ADDENDUM No. 2

DORMITORY AUTHORITY - STATE OF NEW YORK

**Deyo Hall Rehabilitation and Upper Floor Addition
 State University of New York at New Paltz
 3418309999/CR10**

AD.2.1

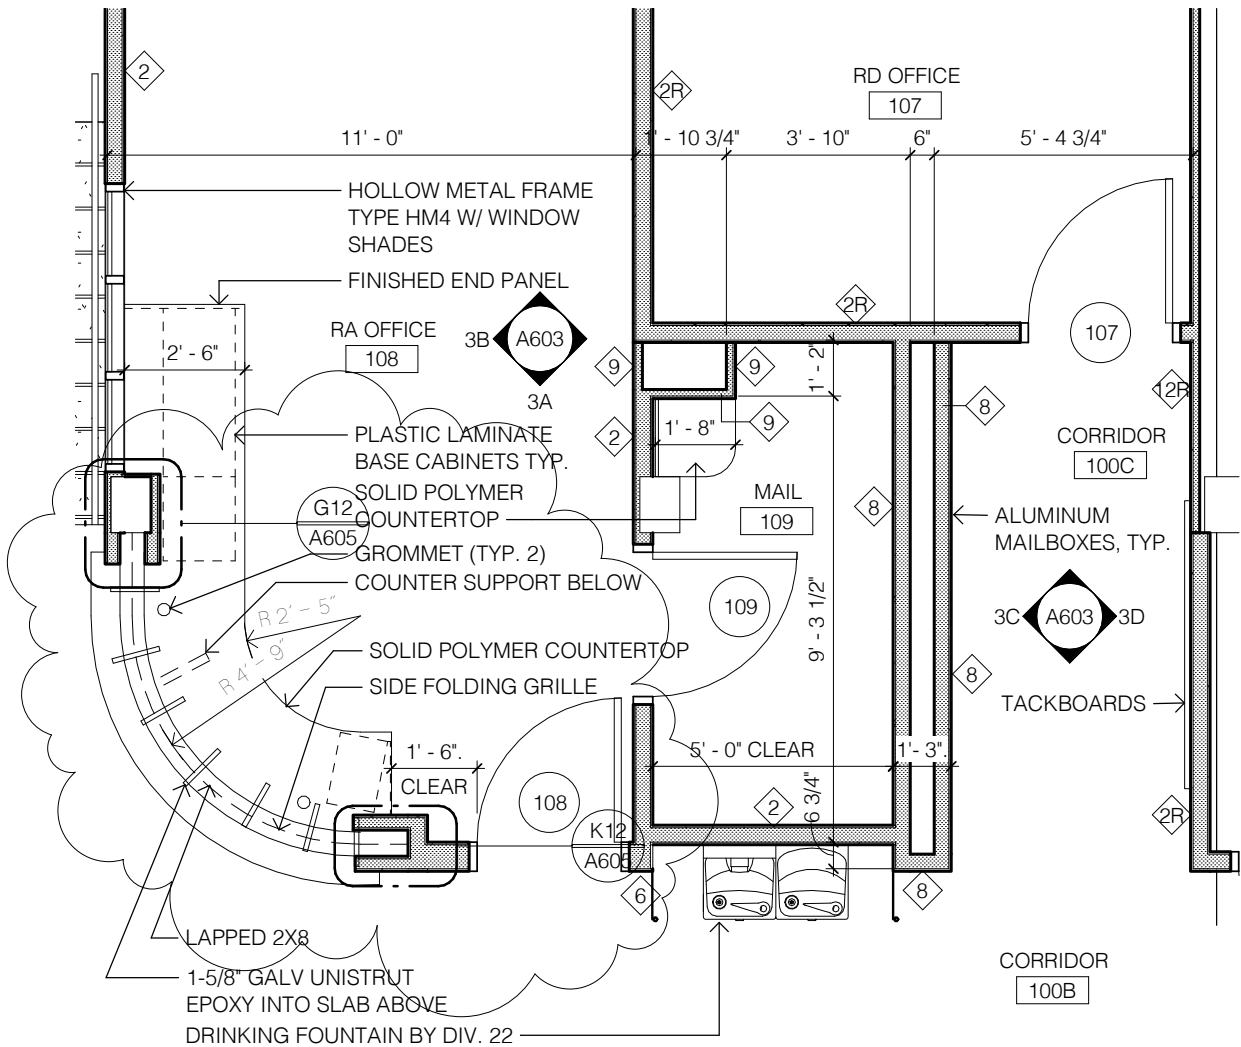
Item #16	A603	REPLACE: Enlarged Plan K1/A603 with attached AD.2.1.
Item #17	A603	ADD: The following bold text to Elevation 2A in G1/A603: " Base Bid: Acrylic spray-on coating. Add alternate: Molded stone panel."
